S E R V I C E N O T E

Agilent 4395A Network/Spectrum/Impedance Analyzer

Serial Numbers: JP1KE00101 / JP1KE01402

Figure 1. AC Inlet Connector

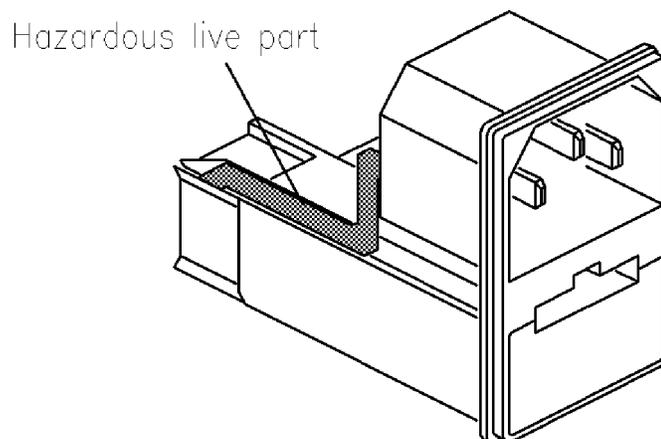
The AC inlet (P/N 1252-6951) has the potential to slip out of the instrument's rear panel slot if the AC power cord is forcefully pulled in a diagonal direction. When this happens, an exposed connection on the AC inlet module may touch the rear panel of the instrument and cause an electrical short if the AC power cord is still connected to the AC power outlet. See Figure 1.

- Remove the AC power cable from the AC power outlet and the product.
- Remove the top, bottom, and side covers.
- Seal the hot line terminal on the AC inlet with silicon paste (P/N 5183-4112).
- Reinforce the connection between the AC inlet and the rear panel with silicon paste.
- Perform Self Test to verify instrument operation.

Figure 2. Repair Completed Label

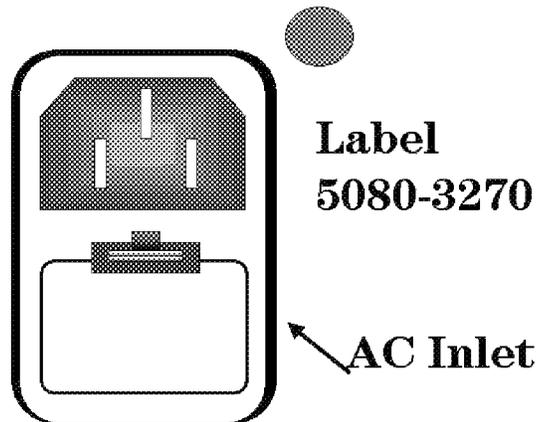
After completing the above instructions, stick the label (P/N 5080-3270) next to the AC Inlet on the rear panel as a mark that this repair has been completed. See Figure 2.
